Modbury church reordering

Site visit by Sue Spackman 25th September 2023

To show Sue Spackman the reordering progress and discuss the areas of minor amendments and areas where the church wishes to move beyond minor amendments.

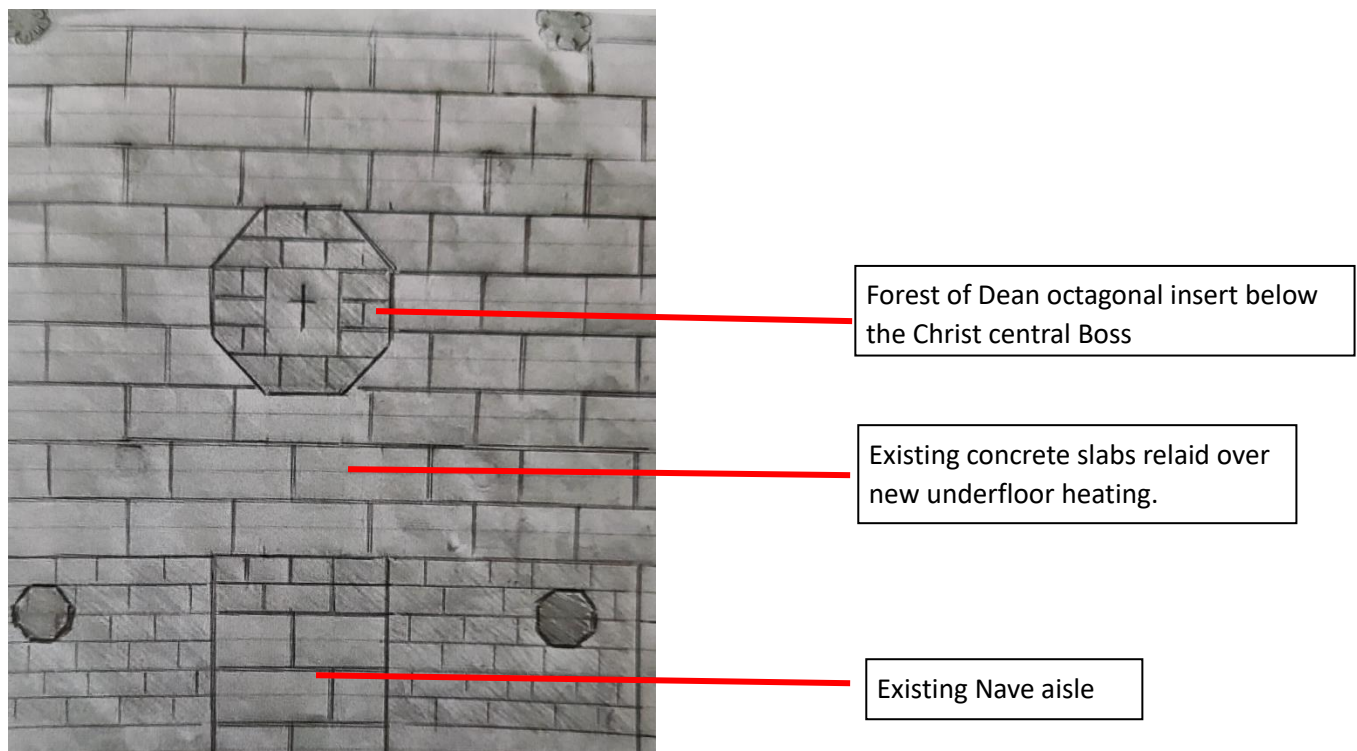
Omitting the wainscot

The existing pew ends abutting the external walls and the panels between were removed as part of the approved works. The lime plaster was very poor and in places missing. It was agreed the church would reinstate a lime plaster along the north and south walls prior to the installation of the new wainscot. This is currently drying out. The PCC (following the principle of not visually re-cluttering the church) now feel that introducing a wainscot over the lime plaster would be unnecessary a) because the poor missing plaster has been replaced and no longer needs covering, b) the plain walls give the space a better quality interior and improved acoustics, c. there is no historic precedent as previously it was pew ends that abutted the wall with infill panels.

If a wainscot were insisted upon they would wish it to be painted the colour of the walls.

North aisle plaster repairs. Drying before painting.

South aisle plaster repairs. Drying before painting.

Stained Forest of Dean floor finish.

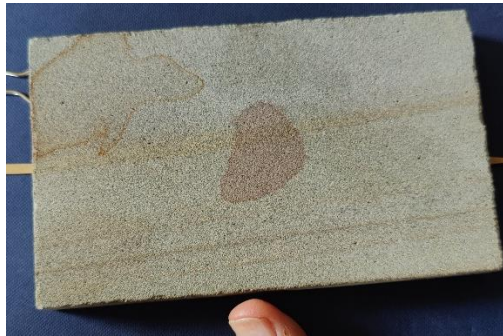
Samples of the Forest of Dean stone are at the church. Currently the approval for the new floor finish comes with the condition that the slab is untreated. It is recognised that this is suggested for reasons of aging the stone naturally, allowing it to breath and to avoid colour change.

The church have identified that the stone easily stains with red wine, tea, coffee, cake (fat content) and other foods. The PCC wish to point out that, in this case, the floor does not breath and therefore the application of a sealant is not detrimental to the integrity of the floor; the use of the church with a servery provides additional staining outside the usual natural aging of the church and lastly the sealant does not alter the colour of the stone. The PCC is also concerned that footfall around the door will quickly show staining from outdoor shoes.

For these reasons they wish to amend the condition to allow a sealant on the stone. The sealant proposed is recognised by the stone industry as one of the better products and acceptable by the Forest of Dean quarry.

Porch door after it was rebuilt in the 1950's, note the doors are painted and a light colour.

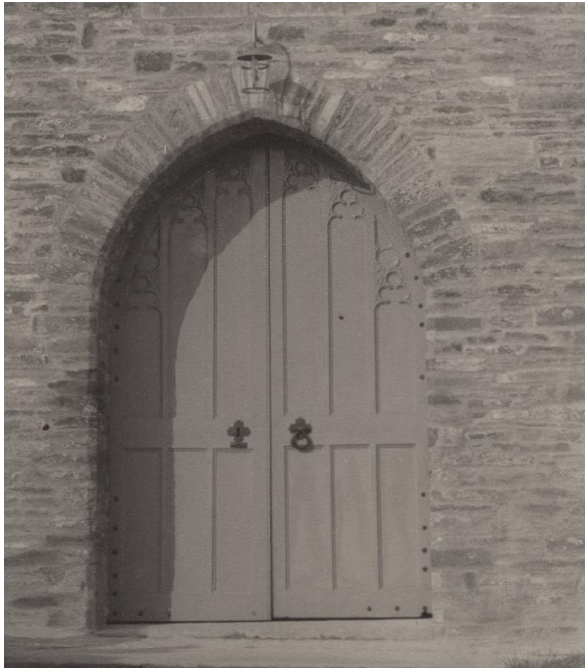
The outer porch door redecoration.

Currently the church outer porch doors are expected to be repaired and re-stained a dark brown. The church porch rebuild photos of the 1950's shows that the doors were painted a light colour. Peeling the paint off the ironmongery the base coat is a blue, similar to the organ pipe colour. Therefore, the current stripped and stained appearance was introduced post the 1950's. The PCC wish to repair and repaint the door a lighter colour to make the church more welcoming. They propose a blue to match the organ pipes.
